3/03 Takoma Park Historic District
7211 Maple Avenue
(REVISION)
3/03-02P

SUBJECT: Historic Area Work Permit #450718, porch addition and alterations, A/C unit

ALTERATIONS TO THE
**HUNTOON-REISER
 RESIDENCE**
 7211 MAPLE AVENUE
 TAKOMA PARK, MARYLAND

MONTGOMERY COUNTY HISTORIC PRESERVATION COMMISSION
STAFF REPORT

2 DECK OVERHANG

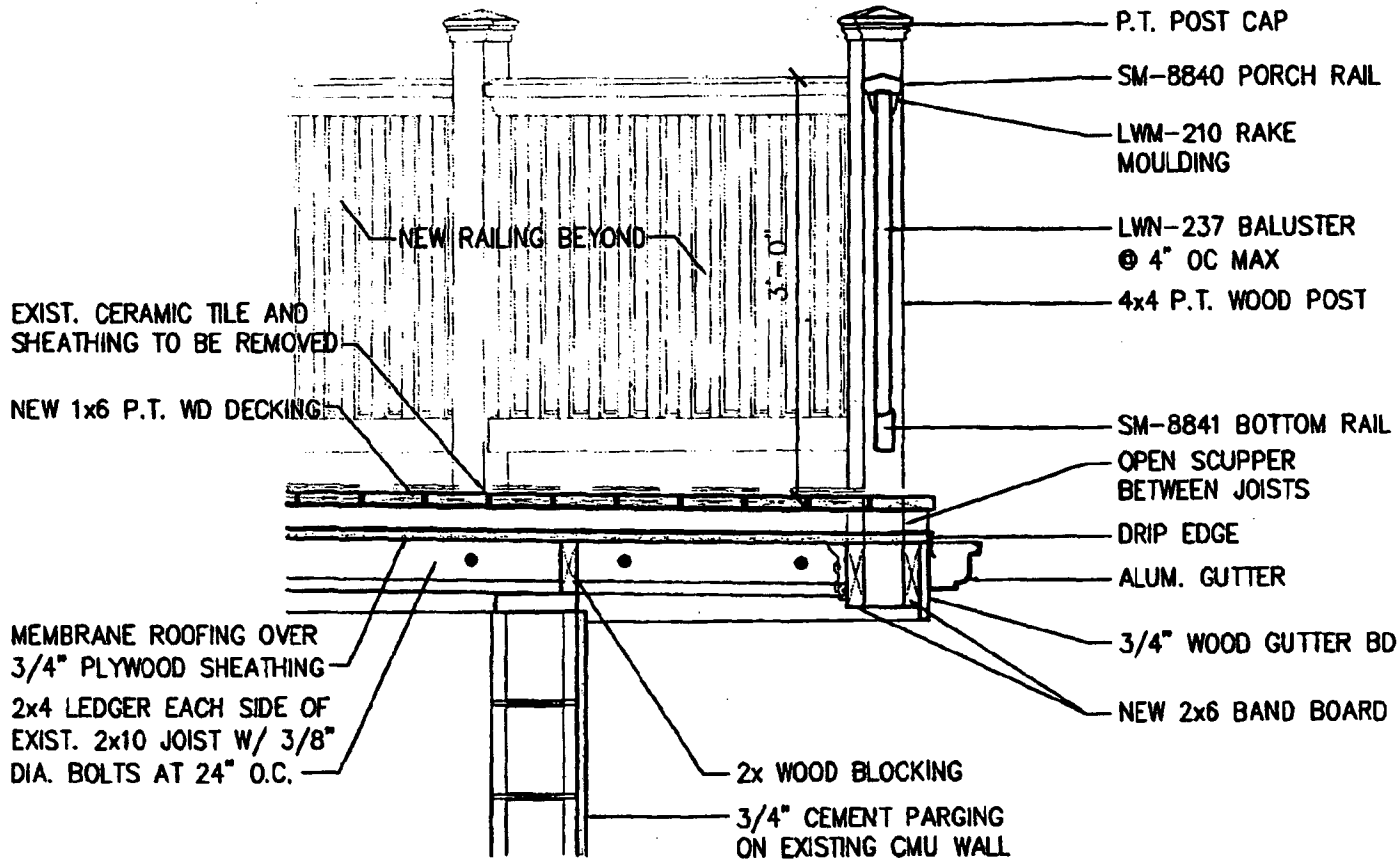
- 1. The applicant will work with the Takoma Park arborist to determine if a tree protection plan is needed for this project. If required, the plan will be implemented prior to any work beginning on the property.*
- 2. Deck railings need to be true balustrades with inset pickets (detail to be shown on permit sets of drawings).*
- 3. The proposed skylight on the new standing seam metal roof must be flat with the roofline.*
